Our Ref: WM/F23010/240823  
Date: 24 August 2023

**PROPOSED DEVELOPMENT OF 20 ACCOMMODATION PODS, 10 HOLIDAY LODGES, MANAGEMENT BUILDING WITH ASSOCIATED INTERNAL ACCESS ROADS, PARKING, LANDSCAPING AND SURFACE WATER BALANCING ON LAND TO THE WEST OF LEICESTER ROAD, BARWELL (HINCKLEY AND BOSWORTH BOROUGH COUNCIL PLANNING APPLICATION REFERENCE: 23/00535/FUL).**

**INGLE NOOK FARM, BARWELL**  
**PROPOSED DEVELOPMENT ACCESS**  
**STAGE 1 ROAD SAFETY AUDIT**

VIEWPORT 1: PROPOSED SITE ACCESS LAYOUT  
SCALE - 1:250@A3

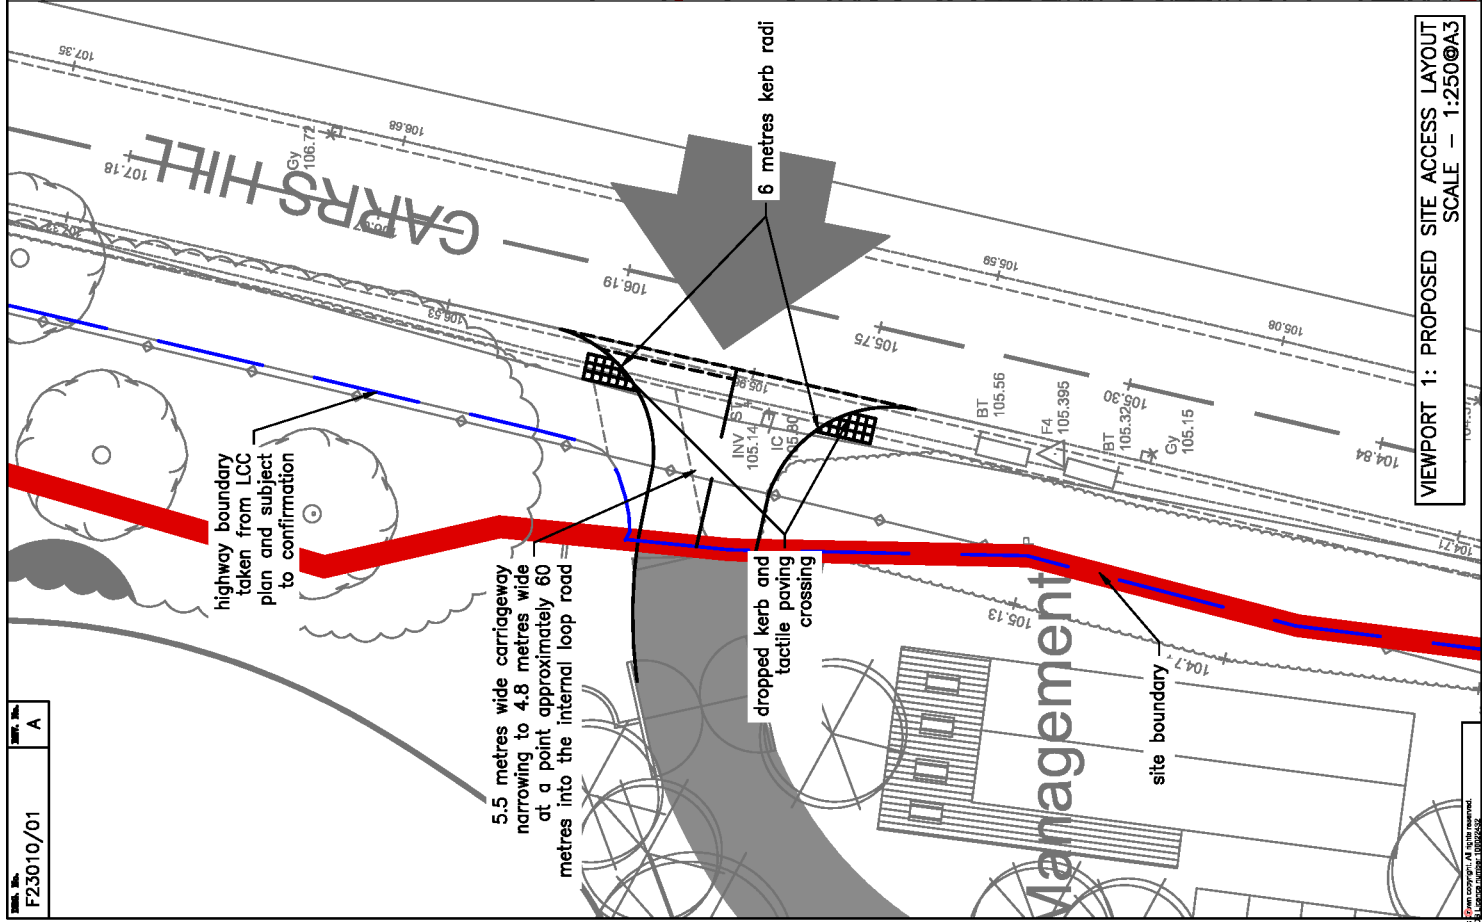
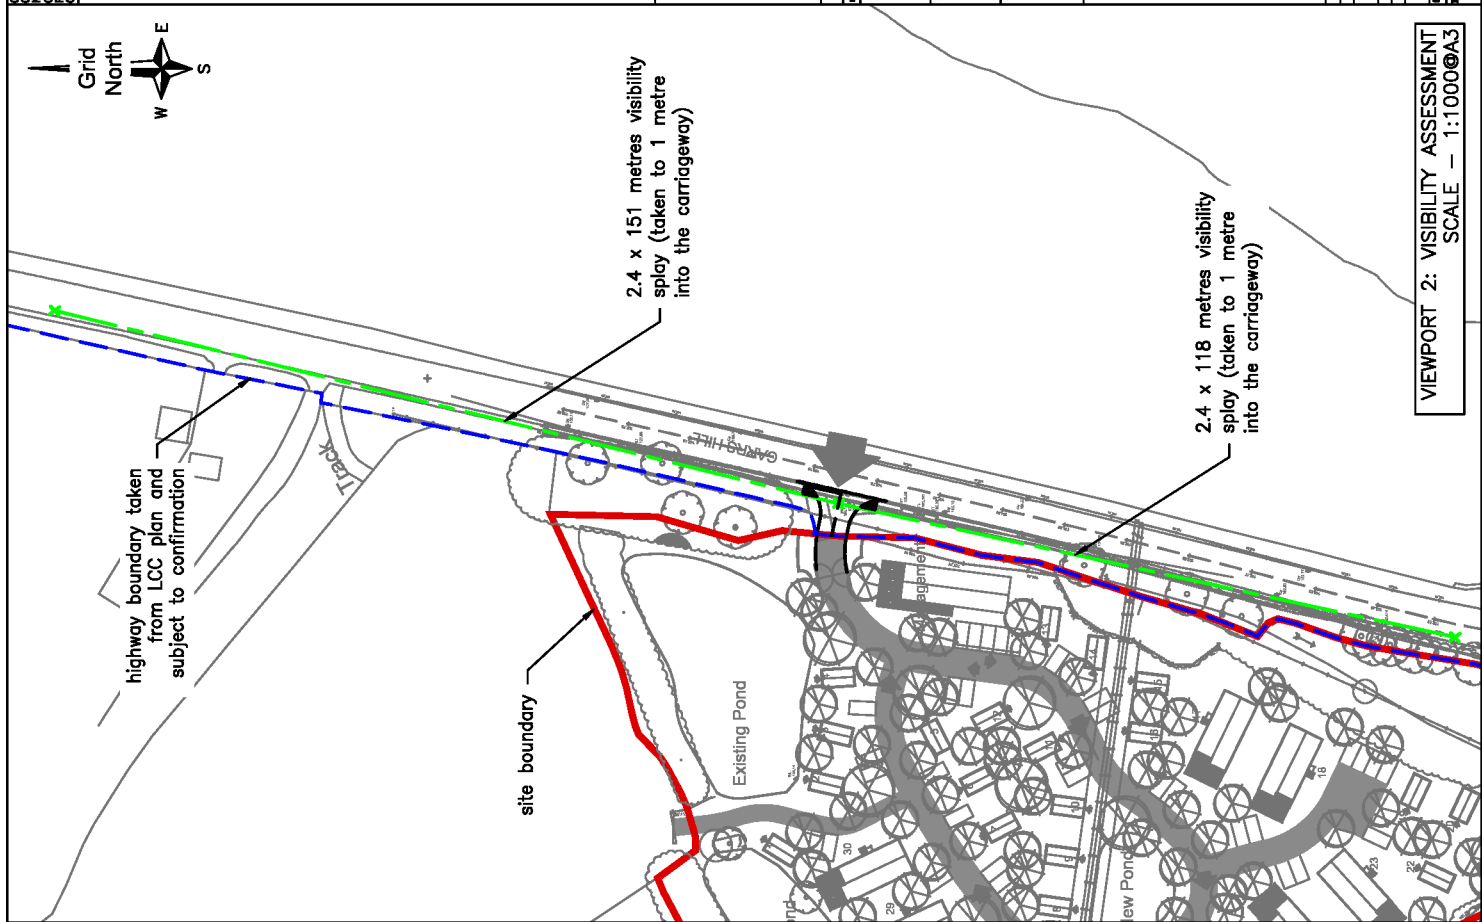
The RSA identified a single 'problem' that related to the achievable visibility splays at the proposed site access. This identified the potential for the presence of existing vegetation impacting the visibility splay to the north. As highlighted in the Design Team Response, **Drawing Number F23010/01 Revision A** demonstrates that the required visibility splays are achievable from the proposed access and could be delivered within land that is confirmed to be within the adopted highway boundary. This point is therefore not considered to be a 'problem' as the maintenance of this area to secure the visibility splay should be the responsibility of the Highway Authority. However, if the Highway Authority were concerned about the vegetation, a suitably worded condition could be appropriate enabling the site owner to carry out their own maintenance of this area if required.

1. The proposed tactile paving layout at the site access.
2. Visibility of the existing warning signs on Leicester Road (dirty and obscured by vegetation).
3. Vegetation encroaching the existing western footway.
4. Unclear pedestrian strategy heading into the site.

- i. Whilst it may be a drawing error, the proposed tactile paving layout across the development access appears to be incorrect. The design team should refer to Guidance on the Use of Tactile Paving Surfaces to ensure that the appropriate layout is implemented.

| <p>The scheme drawings indicate that a visibility splay of 2.4m x 118m is proposed when looking to the right from the proposed development junction egress and 2.4m x 151m when looking to the left.</p> <p>The site visit has established that the achievable visibility splay when looking to the left from the access junction may be impacted upon by the presence of vegetation within the western verge area.</p> <p>A lack of visibility may increase the risk of pull out type collisions.</p> |                                                                                     |

In terms of Point 1, **Drawing Number F23010/01 Revision A** has been amended to provide appropriate tactile paving dimensions in line with the 'Guidance on the Use of Tactile Paving Surfaces' document. This comment should now be addressed.

| <b>Problem Identified (Paragraph No) and Summary</b>                                                                                                                                                                                                                                                                                                                                                                                                                                                                                                                                                                 | <b>Problem Accepted (YES/NO)</b> | <b>Recommendation Accepted (YES/NO)</b> | <b>Measure (describe)</b>                                                                                                                                                                                                                                                                                                                                                                                                                                                                                                                                                                                                                                                                                 |
|----------------------------------------------------------------------------------------------------------------------------------------------------------------------------------------------------------------------------------------------------------------------------------------------------------------------------------------------------------------------------------------------------------------------------------------------------------------------------------------------------------------------------------------------------------------------------------------------------------------------|----------------------------------|-----------------------------------------|-----------------------------------------------------------------------------------------------------------------------------------------------------------------------------------------------------------------------------------------------------------------------------------------------------------------------------------------------------------------------------------------------------------------------------------------------------------------------------------------------------------------------------------------------------------------------------------------------------------------------------------------------------------------------------------------------------------|
| <p>1. <u>3.3 Junctions:</u><br/>Proposed development junction (Drwg.no. F23010/01)</p> <p><i>“The scheme drawings indicate that a visibility splay of 2.4m x 118m is proposed when looking to the right from the proposed development junction egress and 2.4m x 151m when looking to the left.</i></p> <p><i>The site visit has established that the achievable visibility splay when looking to the left from the access junction may be impacted upon by the presence of vegetation within the western verge area.</i></p> <p><i>A lack of visibility may increase the risk of pull-out type collisions.”</i></p> | No                               | Yes                                     | <p><b>Drawing Number F23010/01 Revision A</b> (revised following RSA comments regarding tactile paving) demonstrates that the required visibility splays are achievable from the proposed access and could be delivered within land that is confirmed to be within the adopted highway boundary. This should therefore not be considered to be a ‘problem’ as the maintenance of the verge to secure the visibility splay should be the responsibility of the Highway Authority.</p> <p>However, if the Highway Authority were concerned about the vegetation, a suitably worded condition could be appropriate enabling the site owner to carry out their own maintenance of this area, if required.</p> |

**SWEPT PATH ASSESSMENT  
(FIRE TENDER)**

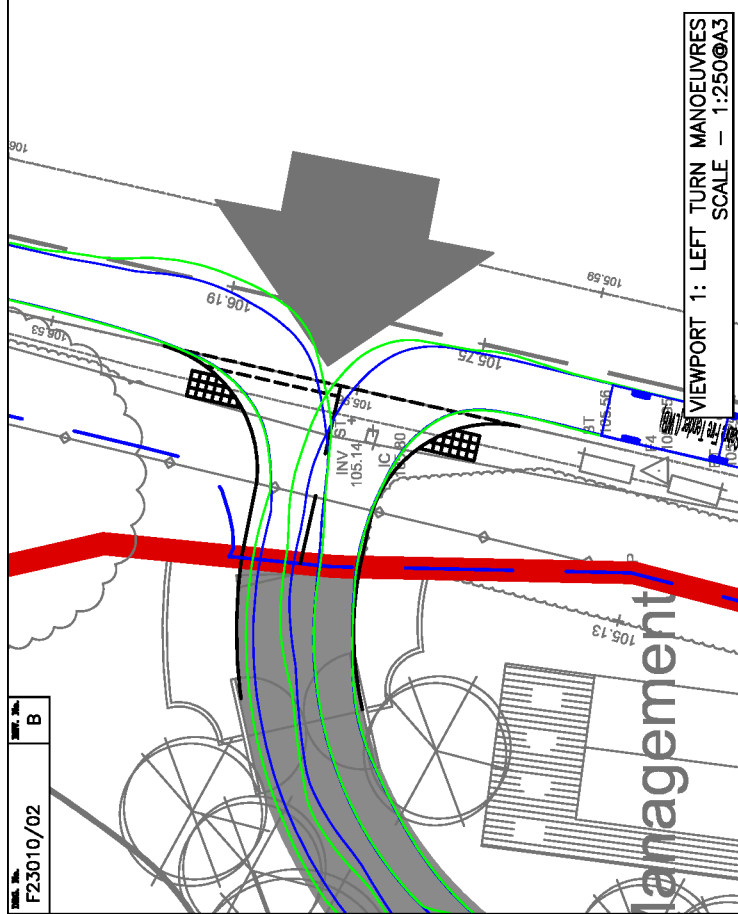
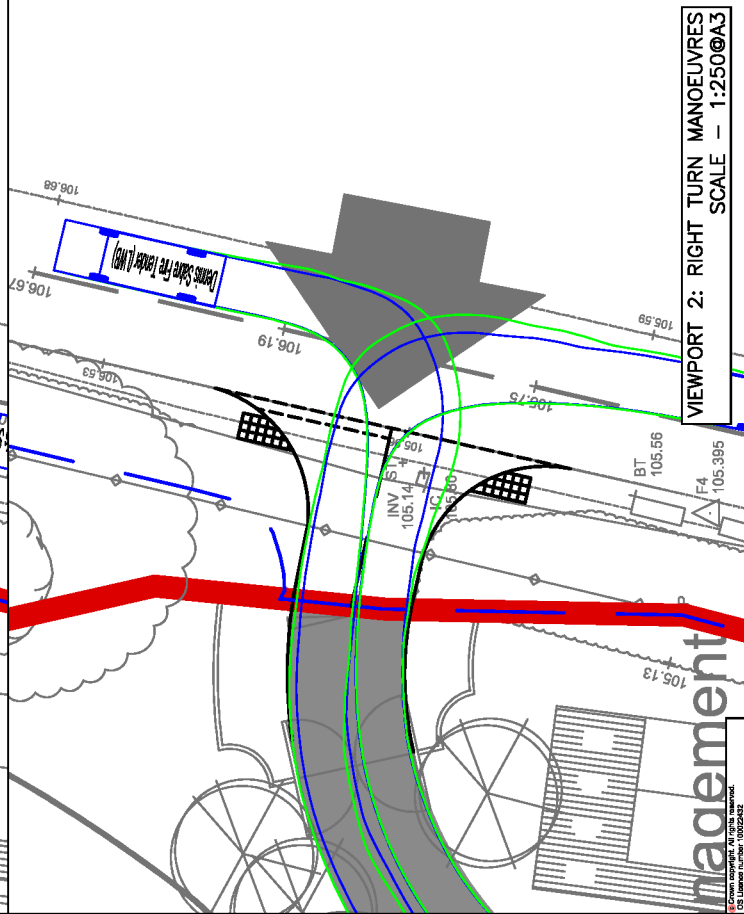
Within the Consultee Comments, LCC stated that *"whilst swept path analysis of a refuse collection vehicle and a fire appliance have been provided, the vehicles have only been shown turning left into and left out of the site access. The LHA request that swept path analysis is shown for vehicles travelling in all directions"*.

Whilst swept path analysis of a refuse collection vehicle and a fire appliance have been provided, the vehicles have only been shown turning left in to and left out of the site access. The LHA request that swept path analysis is shown for vehicles travelling in all directions.

In line with the comments provided by LCC, **Drawing Numbers F23010/02 Revision B** and **F23010/03 Revision B** demonstrate how both a refuse collection vehicle and a fire tender could also satisfactorily turn right in and out of the proposed site access. On this basis, LCC should now be satisfied that the proposed access arrangement is suitable to accommodate all vehicle manoeuvres and ensures that 'safe and suitable' access could be achieved in line with Paragraph 110 of the NPPF.
